Planning Services Sign Permit Review Form

Date of Submittal	Application Number	Applicant	Landowner
10/26/2023	SIGN2310-0005	TMTLA Associates	DRB Group North Carolina LLC.

Contact Person	Contact Number	PIN Number	
Robin@tmtia.com	919-484-8880		
Sign Location	2 Signs Corner of Sheriff Johnson Rd. and Bronze Leaf Dr.; Lots 88 and 89.		0680-38-7921.000 0680-38-8753.000

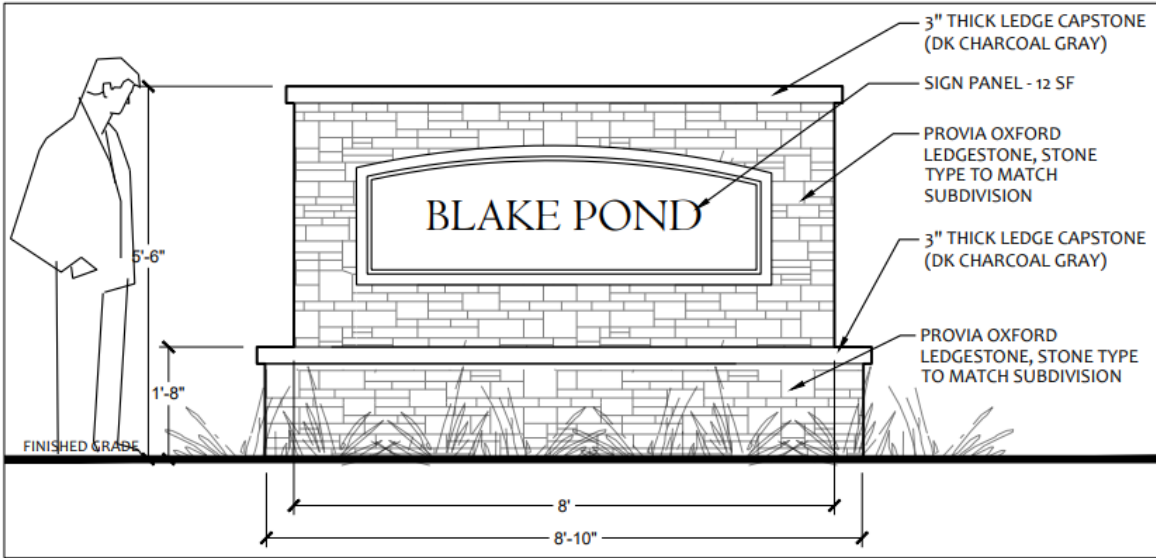
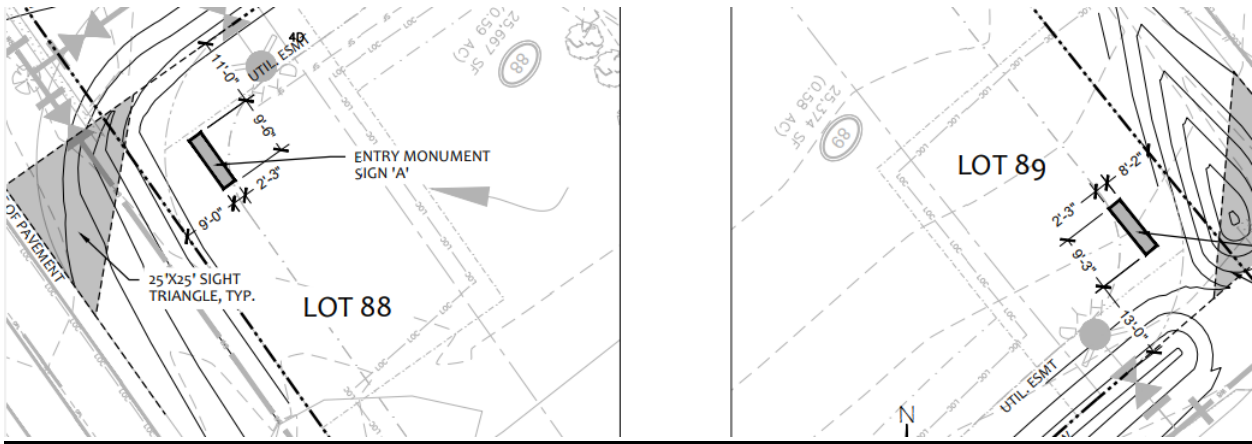
Comments	
	1. When signs are constructed at an intersection, the minimum setback is 20' from each ROW. Please revise the location of the sign on the site plan.
